33510B-03

Modification Recommended Service Note

33500 Series Waveform Generator

Serial Numbers: MY50000000-MY57201152 / SG50000000-SG57200603

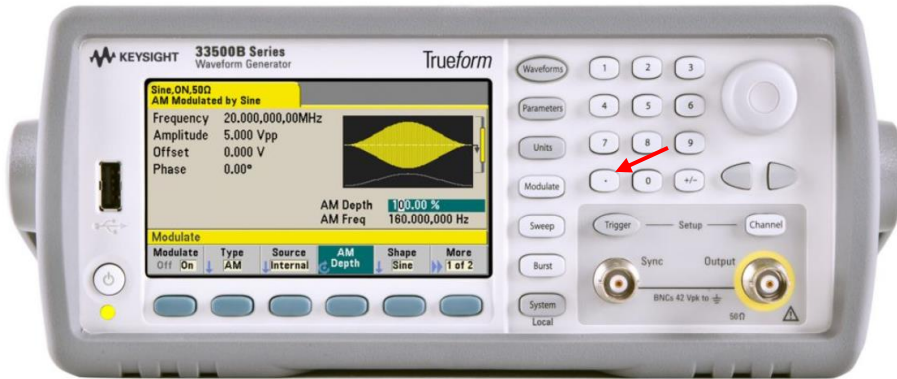
The Problem – The dot key  on front panel intermittently not active.

User may experience the dot key on the front panel intermittently inactive when pressed.

For units with inactive dot key, please return units back to Service Center for repair.

1. Replace the front panel board (part number: 33500-66308).
2. Turn on the instrument and check if the dot key is active when pressed.
